Technical Service Bulletin

MODEL(S) AFFECTED: **Speed Scrub 300 Magnetic Single Disk Models**
Models manufactured before serial number 10745235 (May 08, 2015)

SUBJECT: The magnetic pad driver/brush may possibly disengage if machine is operated on uneven floor surfaces with low down pressure.

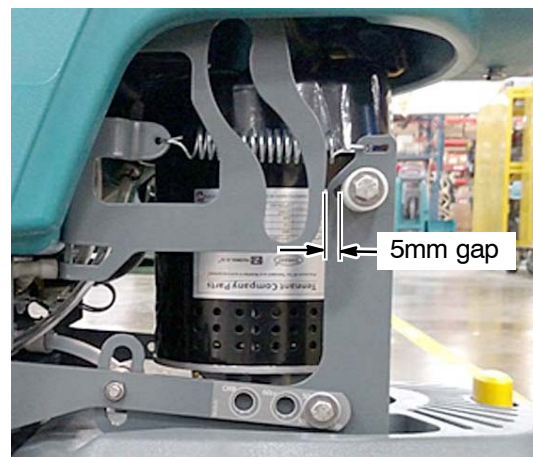
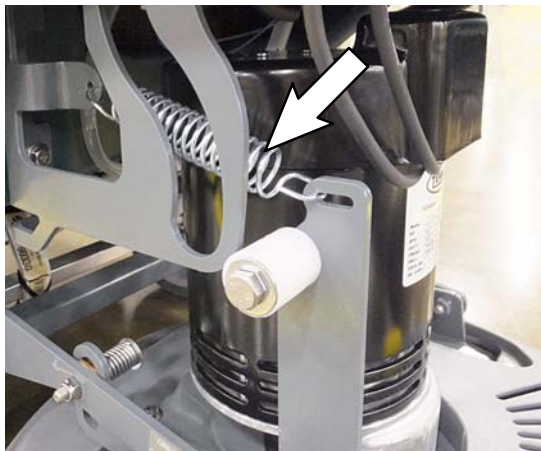
PURPOSE: To prevent the magnetic pad driver/brush from disengaging in this condition, perform the following procedure.

1. Lower scrub head and remove front shroud.
2. Remove existing spring from head lift bracket and install lighter spring p/n 1032420.
4. With the scrub deck in the lowered position, slide the head lift glide back until there is a 5mm gap between the head lift bracket and glide. Re-tighten nut.

3. Using a 13mm wrench, loosen the nut on the head lift glide.
